Response to Comments

BigBeau Solar Project
By BigBeau Solar, LLC/EDF Renewables Development, Inc.

RE: Response to Comments for Draft Supplemental Environmental Impact Report – BigBeau Solar Project by BigBeau Solar, LLC/EDF Renewables, Inc. (PP19161)

FIGURE 4.12-2: NEARBY SENSITIVE RECEPTORS

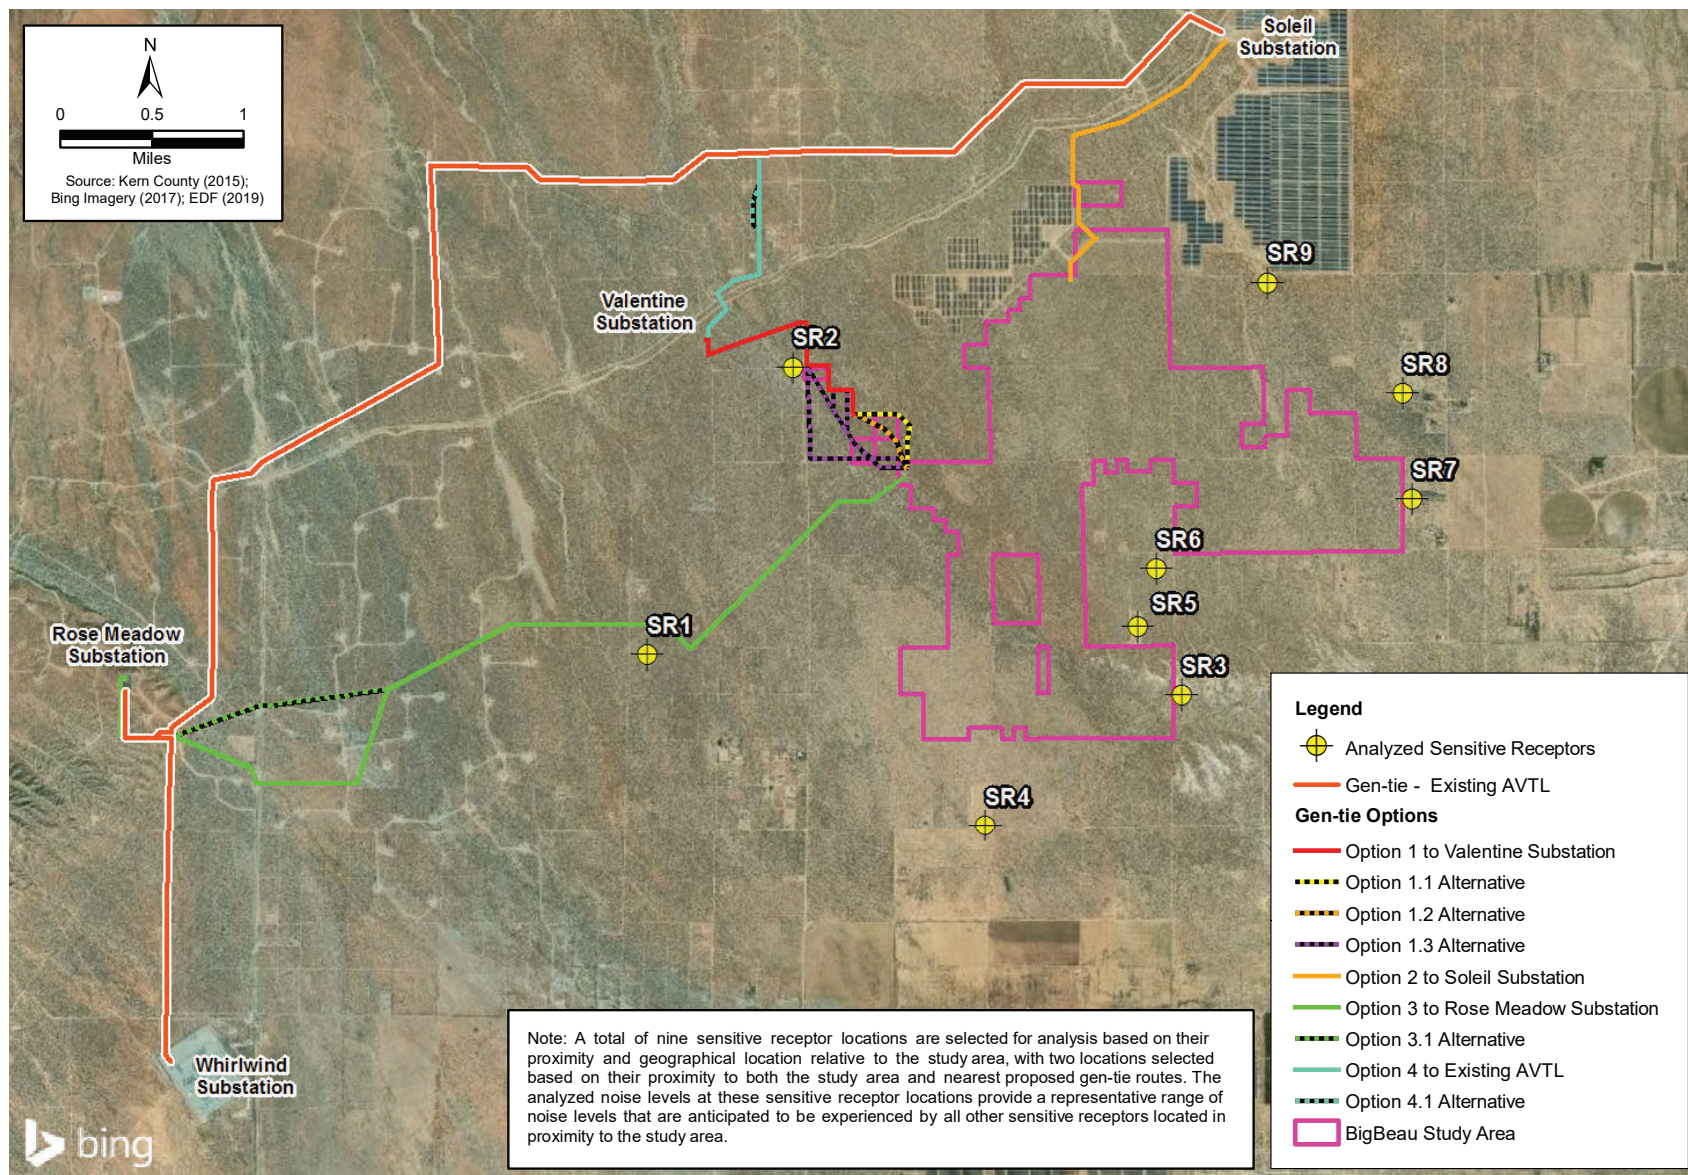
Figure 4.12-2 is not applicable to the project discussion of noise impacts and has been replaced with Figure 4.12-2, *Nearby Sensitive Receptors*.

Figure 1

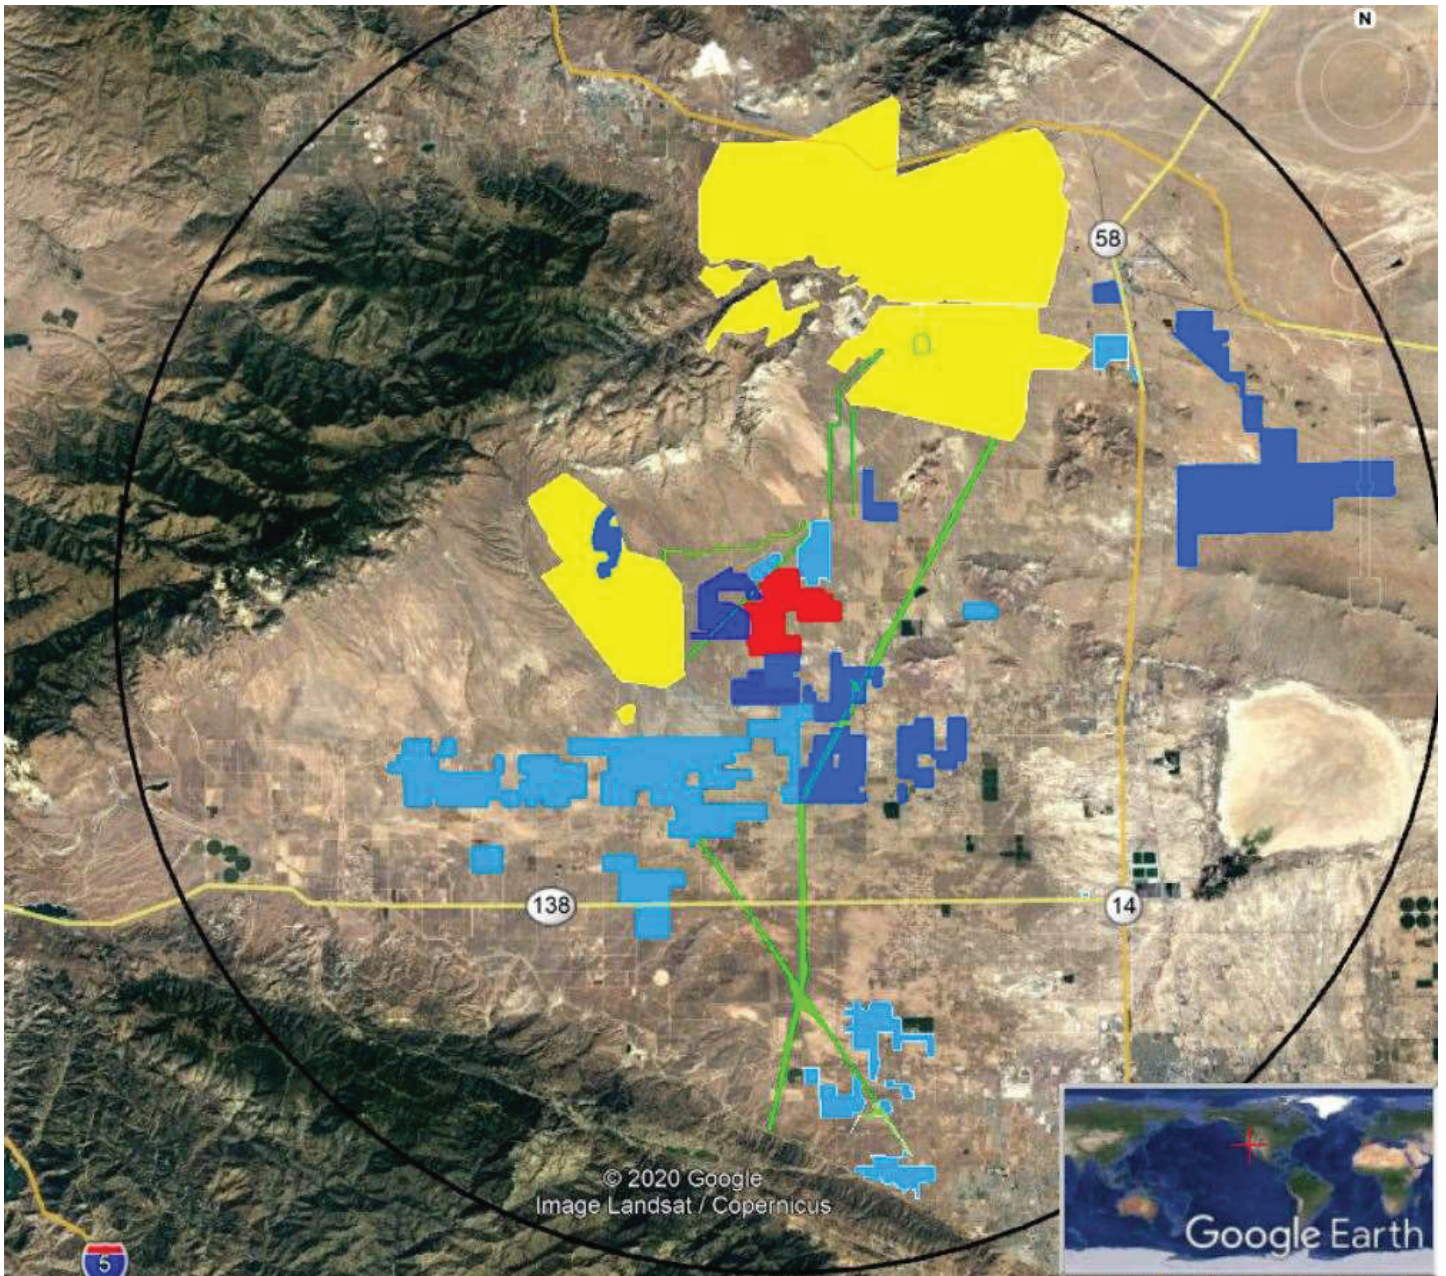
To better illustrate this reality, I have created maps (Figures 1-2) that show the closest existing industrial renewable facilities within a 10 and 20 mile radius to the Project, including some of the major transmission lines. Though not comprehensive, these figures clearly demonstrate that any bird migrating over the Antelope Valley (where the Project lies) and searching for stopovers between Important Bird Areas and Hotspots, e.g. between the Salton Sea and Central Valley, will be exposed to a potentially deadly obstacle course of wind turbines, major transmission lines, and reflective solar facilities, all primary sources of avian strikes and electrocution. This further demonstrates that operational impacts to birds by this Project have been underestimated, resulting in significant impacts unmitigated. As such the DEIR's analysis of cumulative impacts remains inadequate, and must be revisited to demonstrate how impacts are significant and avoidable with appropriate mitigation.

Figure 3

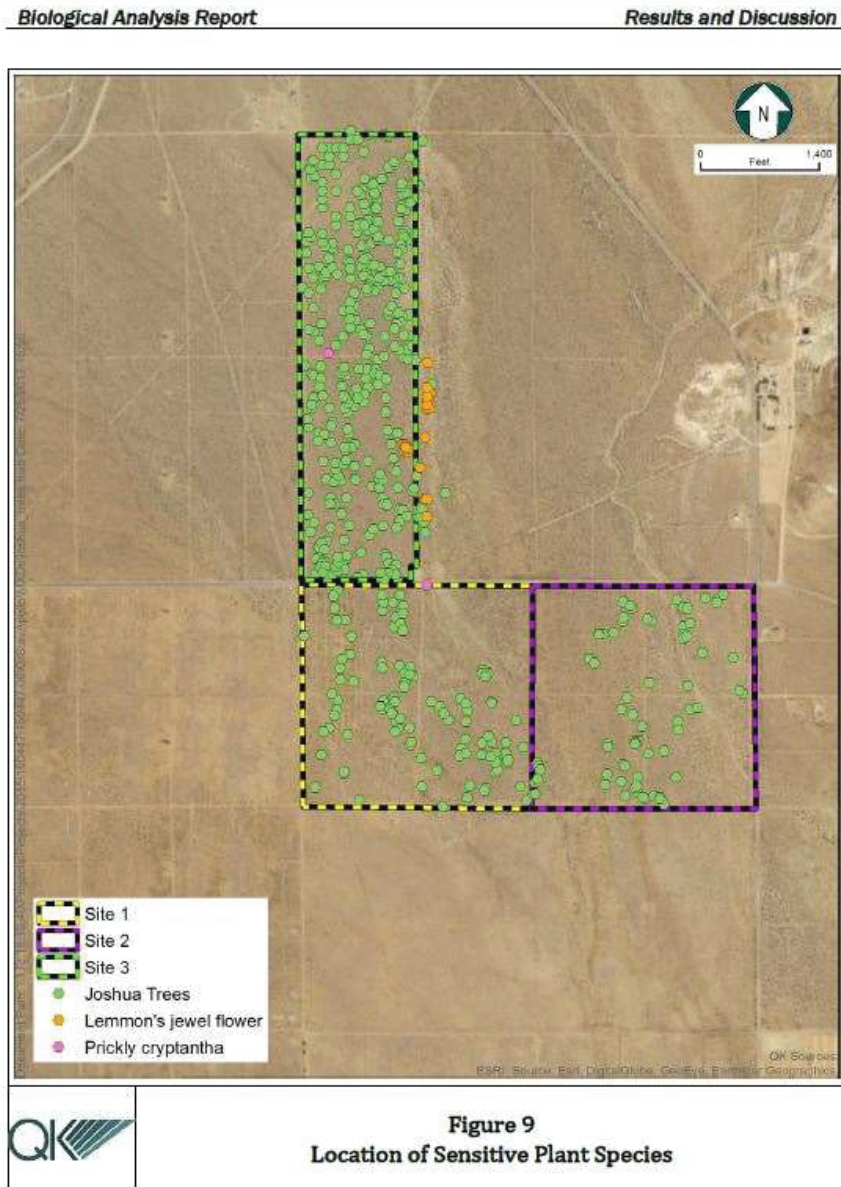
Figure 3 shows the locations and number of Joshua trees for one small parcel of this PSA, located on the proposed Apollo solar site, which is entirely contained within the 5-mile SWHA search radius (Fig 4). Although only a certain number of these trees may have been tall enough to be suitable for nesting, SWHA have been known to nest as low as 5 to 5.5 feet high in various tree species¹² (*pers. obs.*). If the surveys following these continued to search the entire PSA for nests, comprehensive coverage may have been achieved. However, the SWHA report states that the following surveys “focused on surveying those nests that had confirmed SWHA activity, as well as those that were suitable for the species and had not yet been ruled out as already occupied by another species. The final three surveys occurred in Survey Period IV (June 1-July 15) and focused solely on updating the status of those nests that were confirmed during previous surveys to be in use by SWHA.” In summary, the only surveys conducted for the “entire” PSA occurred on the three days discussed above. Clearly it is physically impossible for comprehensive surveys to be conducted given the time/person hours spent surveying the 5 mile radii that is the PSA.

Figure 4: 2014 Statewide All Fleet Sizes (Pieces of Equipment)

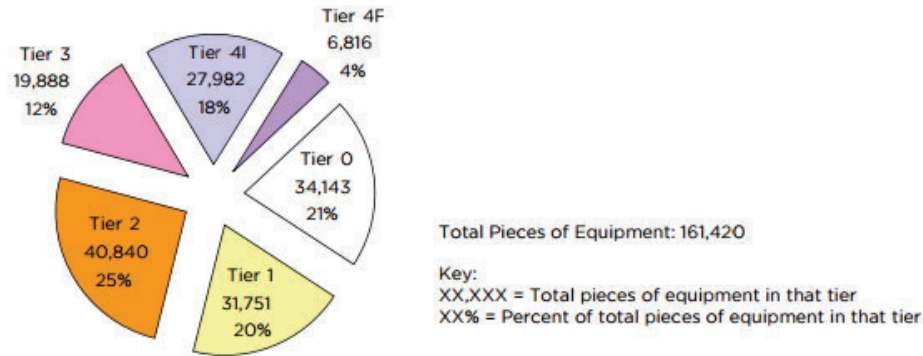
As demonstrated in the figure above, the Tier 3 equipment only accounts for approximately 12% of all off-road equipment currently available in California. Emissions for Project construction are modeled assuming that the Project will be able to obtain Tier 3 equipment even though this equipment only accounts for 12% of available off-road equipment currently available in California. As a result, the model represents the best-case scenario even though obtaining this type of equipment may not be feasible. This is incorrect, as CEQA requires the most conservative analysis. Due to the limited availability of Tier 3 equipment, the DEIR should have evaluated the feasibility of obtaining Tier 3 equipment. As a result, construction emissions may be underestimated.
